Bhuyan Warmtex (Pvt) Ltd.

17th June 2014

Observations

No Perimeter Protection to Roof

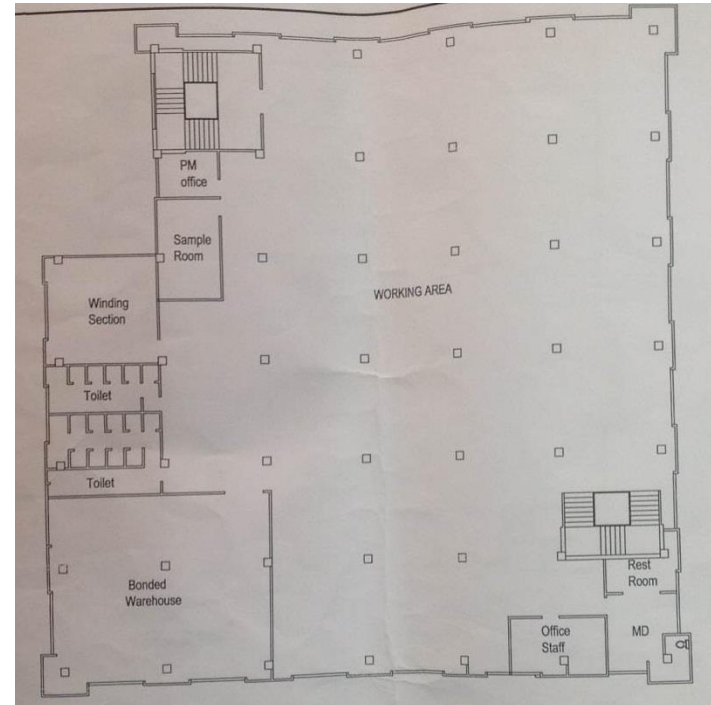
No handrail or edge protection provided at roof level and no access restrictions

Building 1 - Localised high loading

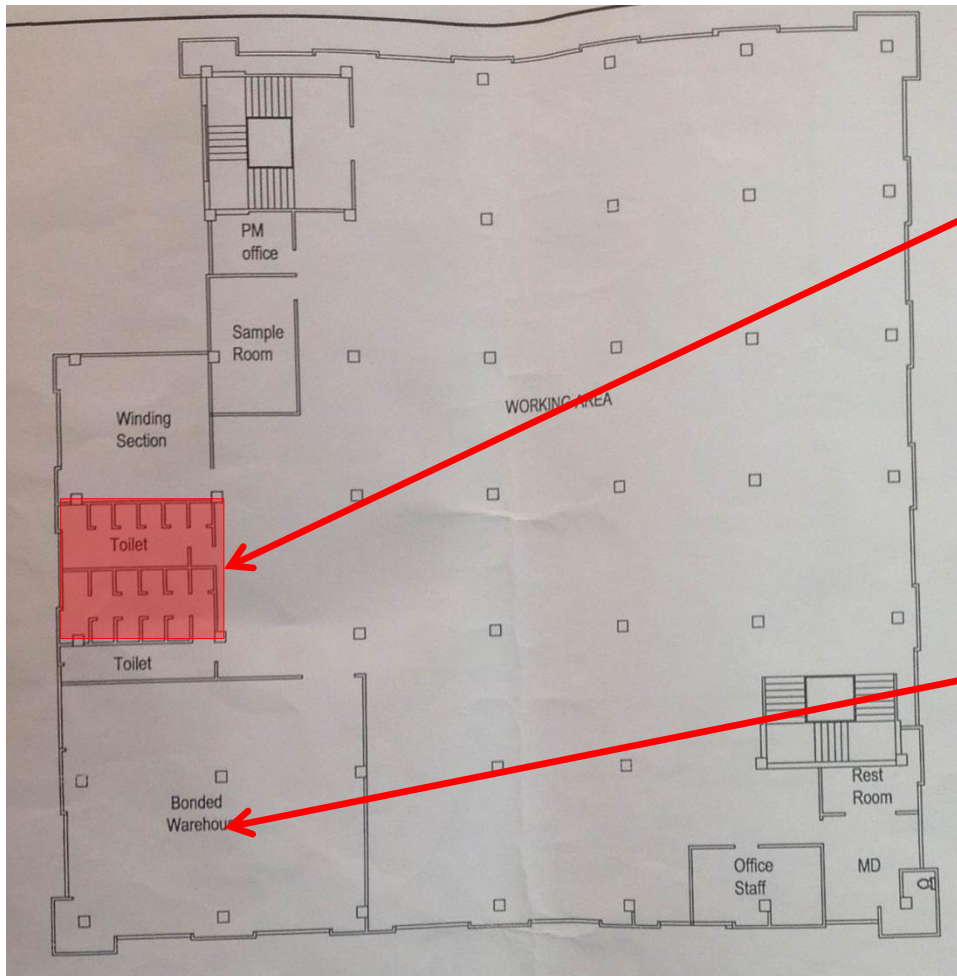
High loads were observed in the bonded warehouse on first floor. Controlled stacking of raw material was also observed in areas outside the bonded warehouse on first floor. Building engineer to produce a loading plan for all floors giving consideration to floor and column capacity
